Subject: Quad Cities Station Unit 1  
Supplementary Information on  
IGSCC Weld Inspection Results  
NRC Docket No. 50-254

QUAD CITIES UNIT 1  
IGSCC WELD INSPECTION

RESPONSE TO NRC QUESTIONS ON OUR  
JULY 2, 1984 SUBMITTAL

DISPLAY OF CIRCUMFERENTIAL CRACK INDICATIONS  
12" RISER WELDS 02J-S4 AND 02K-S3  
QUAD CITIES UNIT 1

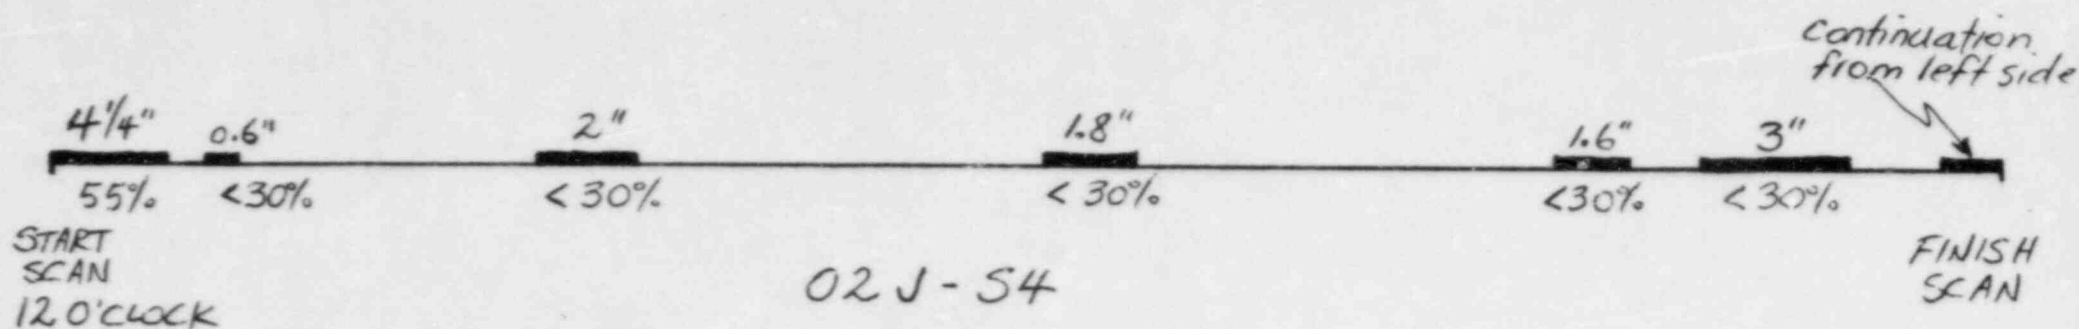
What are the applied stress components and stress ratios for welds 02J-S4 and 02K-S3?

<u>Weld #</u>	<u>Dead Weight</u>	<u>Thermal</u>	<u>Seismic</u>	<u>Pressure</u>	<u>Ratio</u>
02J-S4	118	161	216	6811	.43
02K-S3	225	624	339	6811	.44

All stresses are in units of psi.

For 304 stainless,  $s_m = 16800$  psi

A sketch of the location of the individual circumferential indications for both 02J-S4 and 02K-S3 is attached.
